Field campaign

Topic	Tonneau micro switch – mounting bush orientation (SC14/21)
Market area	Bentley: worldwide (2WBE)
Brand	Bentley
Transaction No.	2037971/1
Campaign number	EA21
Note	
Type	Workshop campaign
US code

New Continental GT Convertible

Figure 2

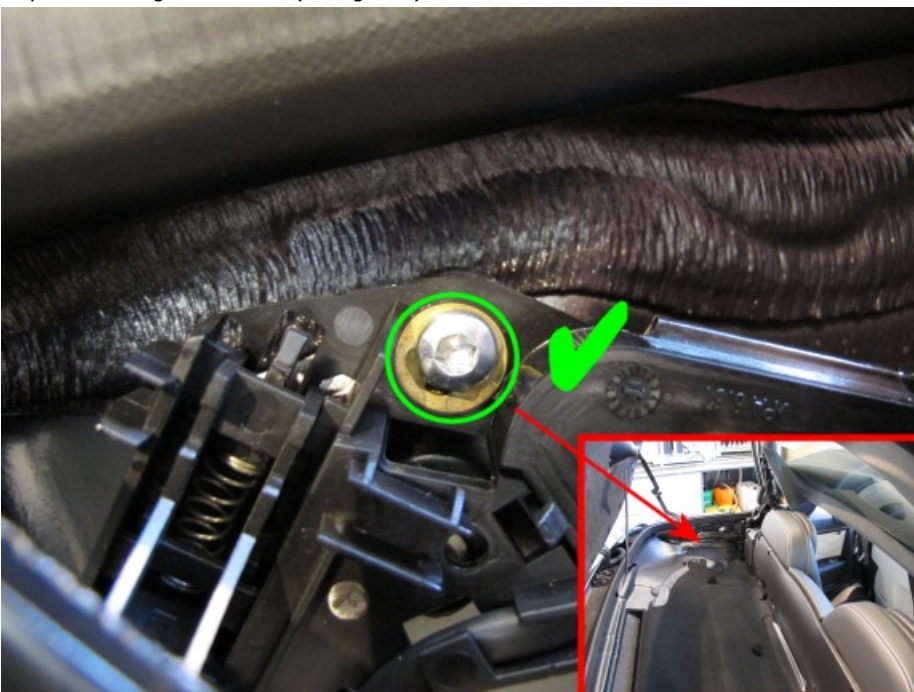
2. Referencing figure 2 locate the tonneau cover hinge micro switch assembly, it is located on the left hand tonneau hinge

3. Inspect the tonneau cover hinge microswitch assembly securing bush. Figure 2 shows the correctly oriented brass bush with the fastener head bearing on the 'top hat' section of the brass bush. Figure 3 depicts an incorrectly manufacture assembly where the brass bush is inverted and the top hat section is not visible. This failure will result in the switch housing assembly lifting off the bush resulting in the convertible roof failing to operate

Figure 4

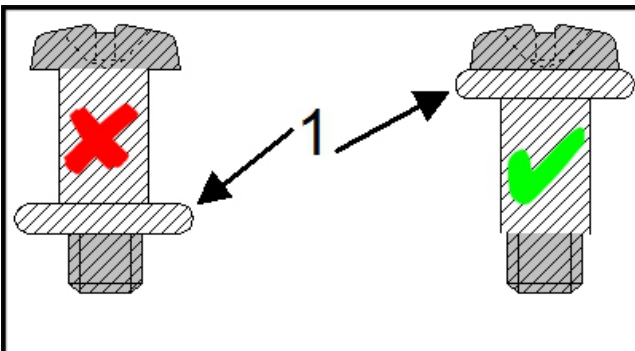
4. If the 'top hat' bush (1) figure 4 is correctly oriented then apply a blue campaign completion mark to the switch housing no further work is required (see Figure 5). If the housing is found to contain and incorrectly orientated bush then replace the switch assembly (part number 3W7953229A) Rep Gr 61 Tonneau cover hinge microswitch – To remove, fit and set

Figure 5

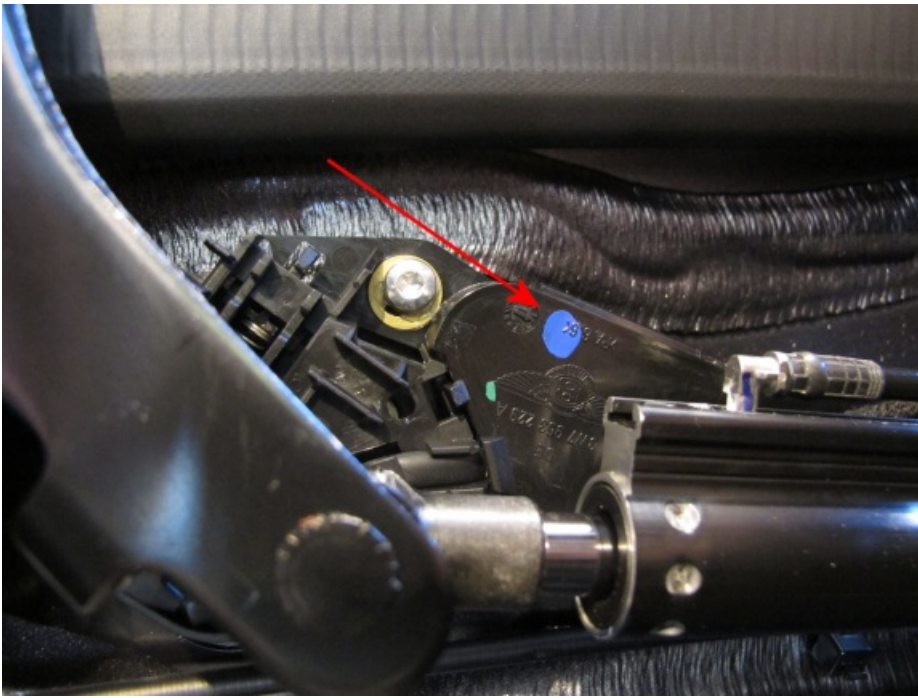
On completion apply a blue campaign completion mark to the switch housing (see Figure 5)
